Response to MassDevelopment with Respect to
The Residences at South Brookline

RE: Chapter 40B Comprehensive Permit

Project Name: The Residences at South Brookline
Location: Independence Drive, Brookline, MA
Number of Proposed Units: 271
Subsidizing Agency: Massachusetts Development Finance Agency
Applicant: The Residences of South Brookline, LLC
Development Company: Chestnut Hill Realty

Figure 7: Detail Ring Plan

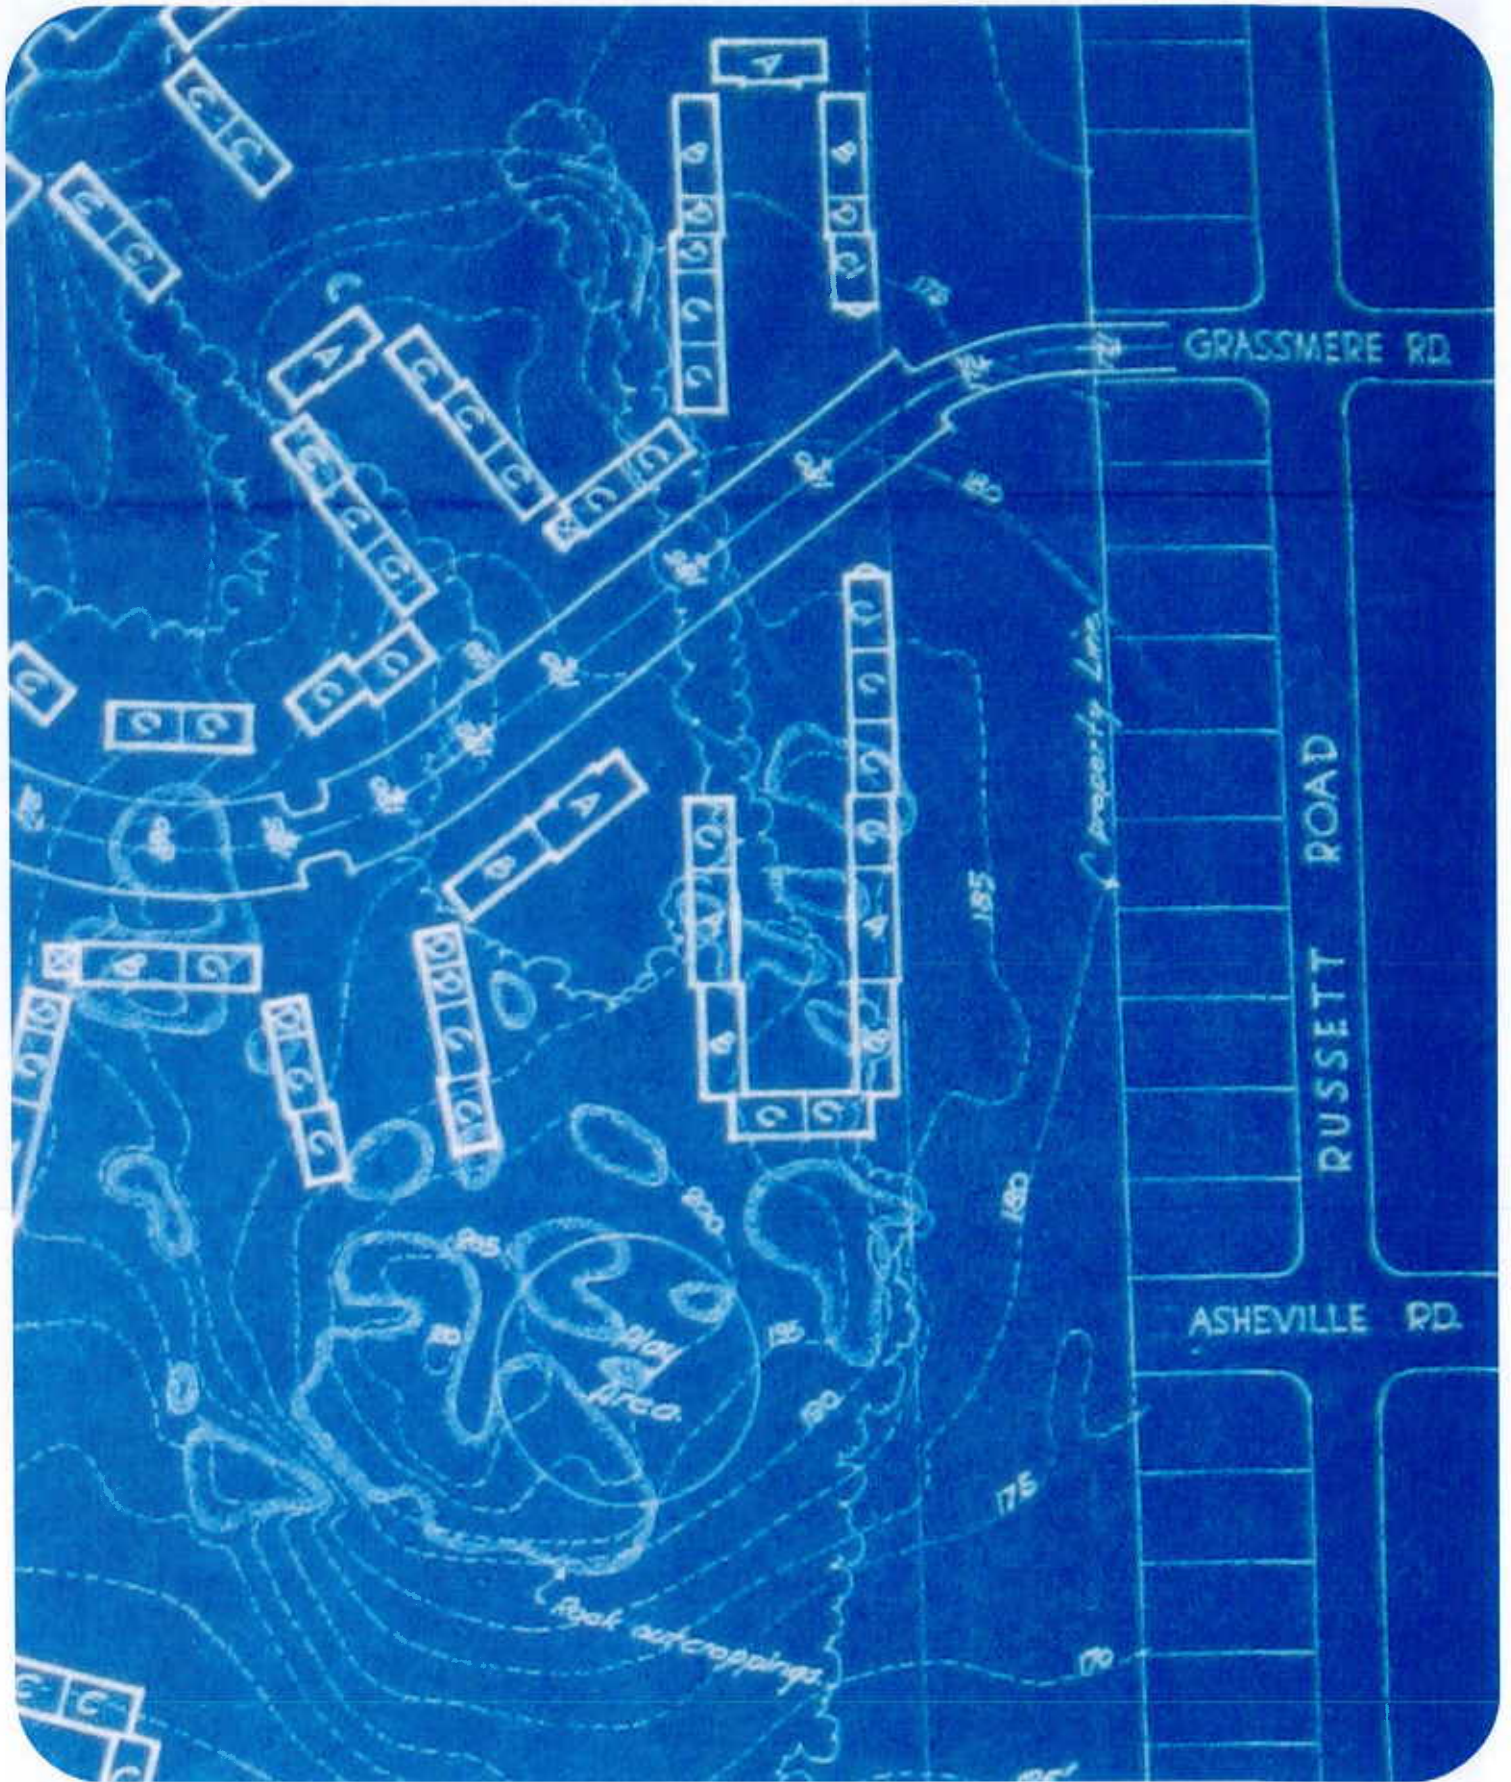
Whereas the original vehicular pattern for Hancock Village was circular and integrated (see Ring Plan – **Figure 6**), the proposed plan would add four additional dead end driveways. This type of site planning not only compromises the free and open feel of Hancock Village, but also worsens accessibility for emergency vehicles. It appears from the information provided by the developer

The proposed project would more than double the number of vehicles whose sole access would be to and from this rear 18-foot wide driveway which will negatively impact the community through an increase in motor vehicle volumes and speeds. Perpendicular parking spaces would also be added to the end of Asheville Road at the site's edge. The site plan does not include safe, adequate or separate pedestrian access at this edge of the site. Most of Baker Elementary School children and their families walk to school; the Russett/Asheville Road

intersection would become more dangerous due to the significant increase of vehicular movements.

Figure 10: Limited Sight Distance Plan

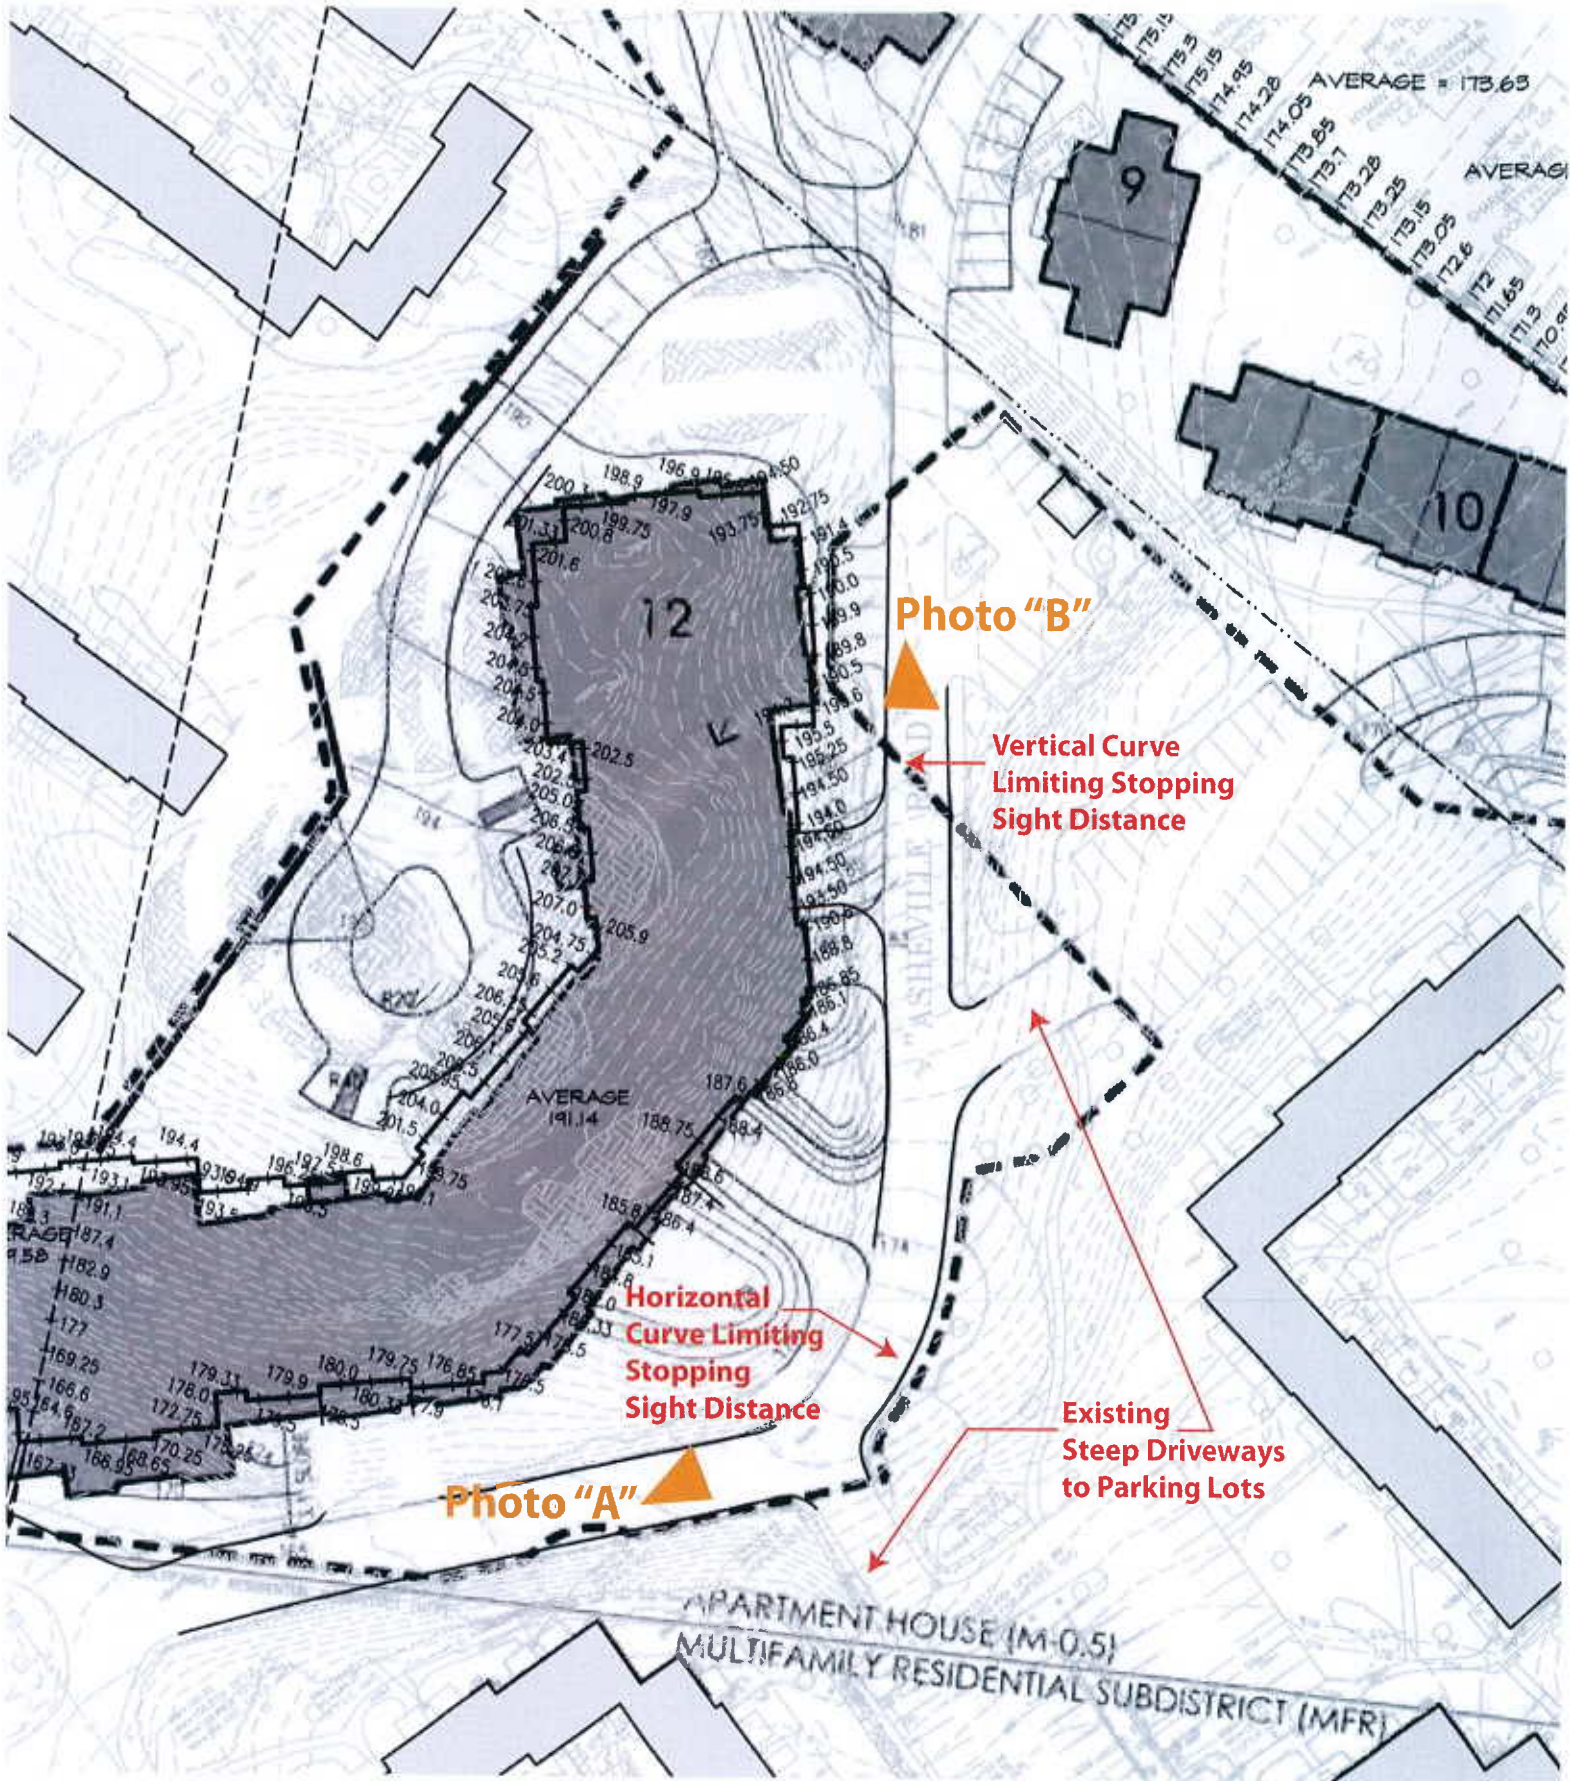
The proposed five-story apartment building is sited such that two new intersections will be created along the curve of the existing Asheville Road driveway. Standard safe Stopping Sight Distance (SSD) for a 15-mph zone is 80 feet. However, as shown in **Figures 10 and 11**, horizontal and vertical curves in the existing Asheville Road driveway, combined with multiple parking lot driveways entering at very steep grades, already limit the line of sight. The submitted application does not include information related to Stopping Sight Distance. The Town estimates that the Stopping Sight Distance along this driveway as proposed will not meet these standards. With 144 additional cars entering and exiting along the curved driveway, the proposed project design for this large building cannot be accommodated on the Asheville Road driveway.

Note: Plan shown is 1"=60' scale. The base plan (existing topo) has been combined with materials submitted recently for the Comprehensive Permit to better illustrate the inappropriateness of utilizing the driveway off Asheville Road for vehicular access/egress to the proposed building. Photos A & B included as Figure 11.

Scale: 1"=50'
Figure 13: Russett Road Neighborhood Section

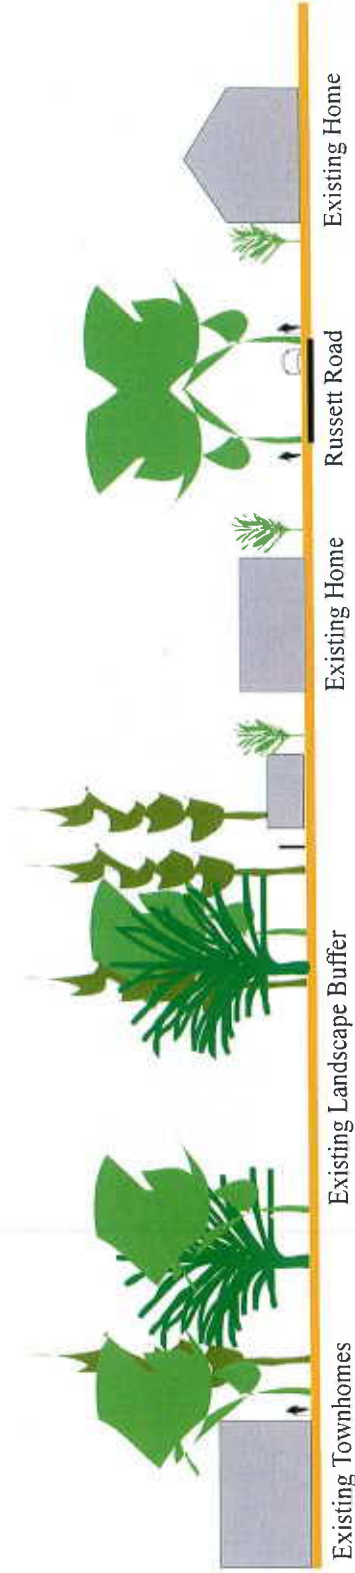
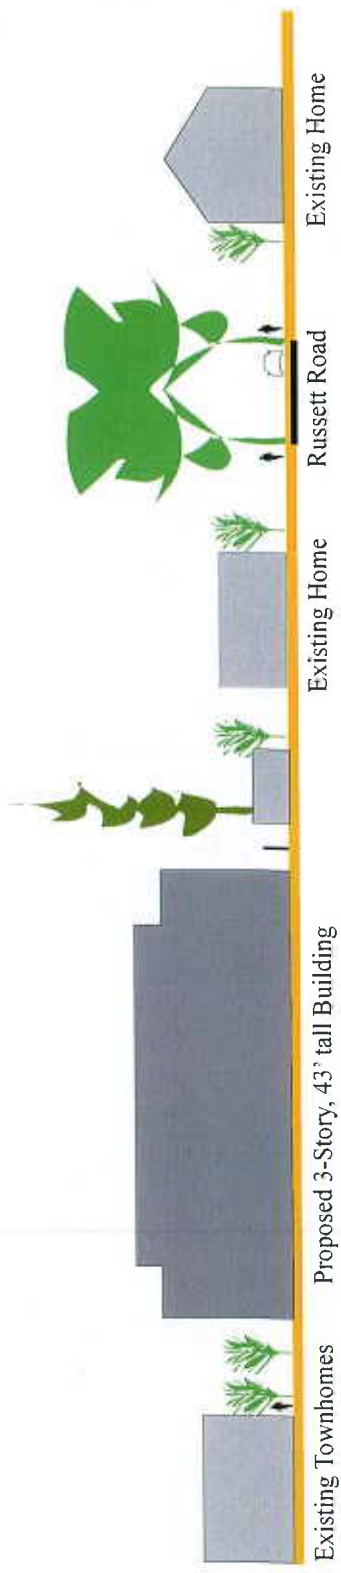
As shown in the attached Russett Road Neighborhood Section (**Figure 13**), multi-family buildings as proposed will not only eliminate completely the existing greenbelt between Hancock Village and the adjacent single-family neighborhoods, but will also set the proposed buildings within five feet of the adjacent single-family lots.

Figure 14: Hancock Village Neighborhood Section
Scale: 1"=30'

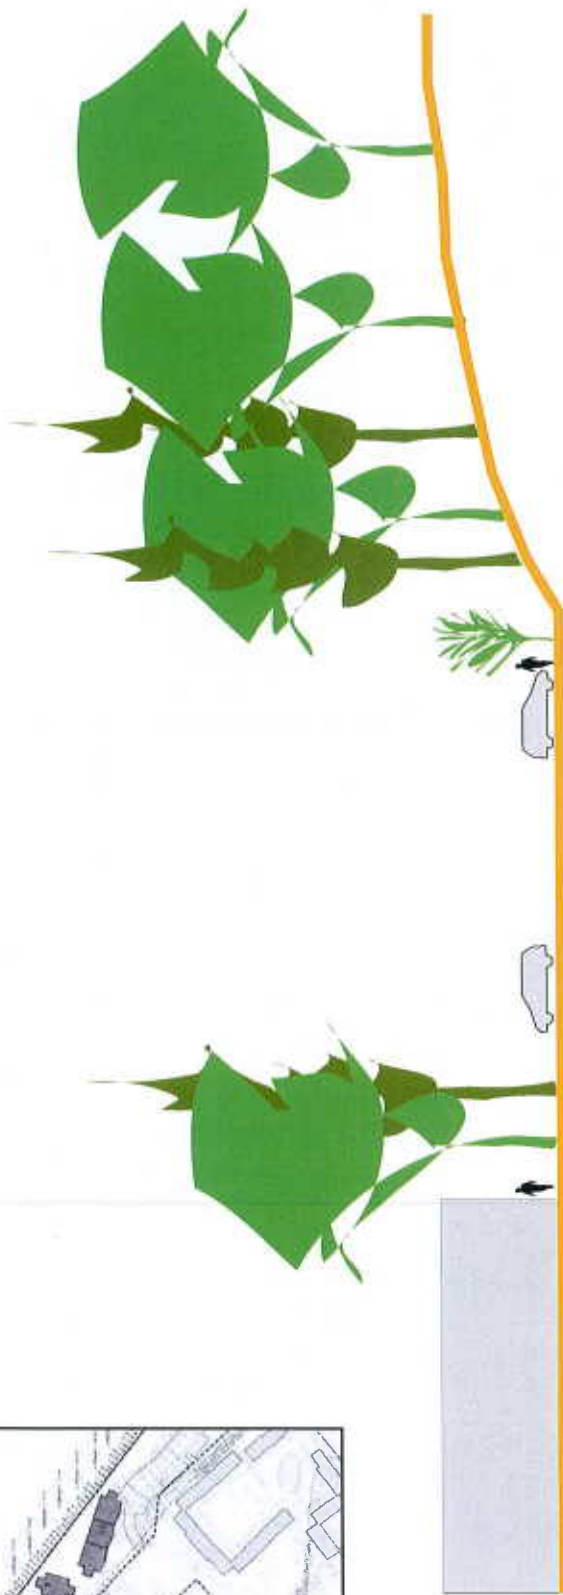
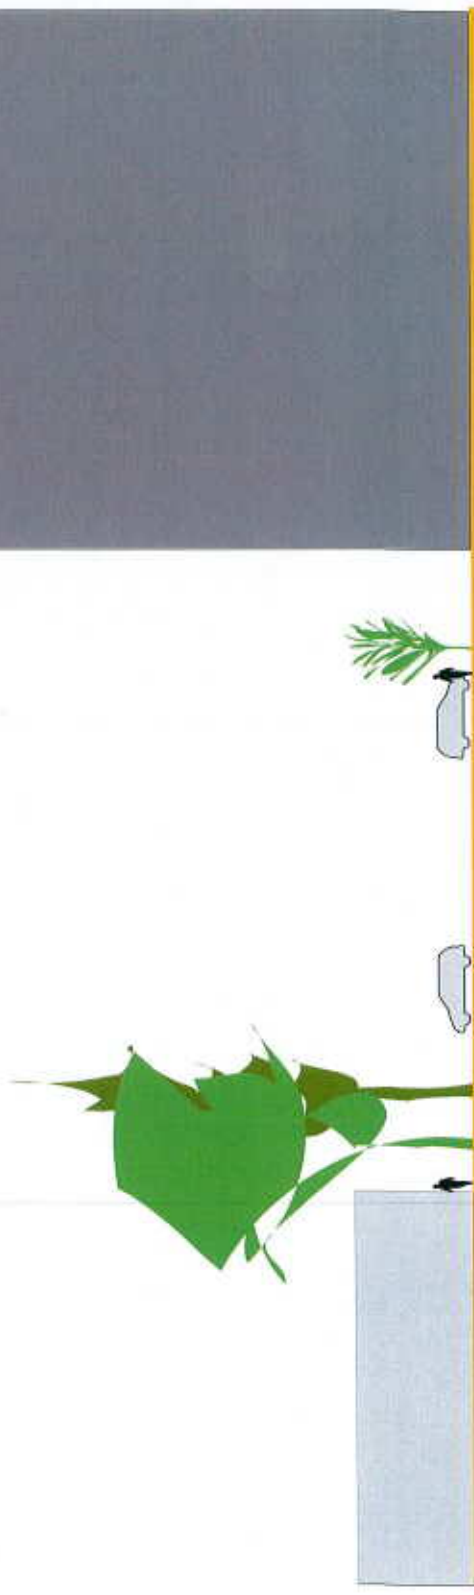
As shown on the proposed building elevations, the 11 three and one-half story multi-family buildings do not modulate in any significant way to fit in with the existing multi-family buildings within Hancock Village. They also would be out of place and scale compared to the one- to two-story single-family homes in the surrounding neighborhood. The height of these proposed 43-foot tall flats would not fit well into the streetscapes of Independence Drive or Asheville Road and would block existing view-sheds from within and without Hancock Village. The “stepping down” in height and depth on the narrow bays at the buildings’ ends seems gratuitous given their oversize massing, volume and scale. The buildings are proposed to have pitched rooflines across deep floor plates, with windows cut into the roof line, which creates a visual fourth floor across these buildings.

The existing buildings' massing is narrow front to back and low, whereas all of the new construction is wide and high. The proposed and existing buildings bear no relation to one another, and the existing townhouse blocks are diminished by the treatment of the proposed units. The chief aim of historically sensitive design is harmony and unity. The insertion of these new building types would clearly create discord in a National Register-eligible development whose sensitive siting, massing, and planning are keys to its historic importance.
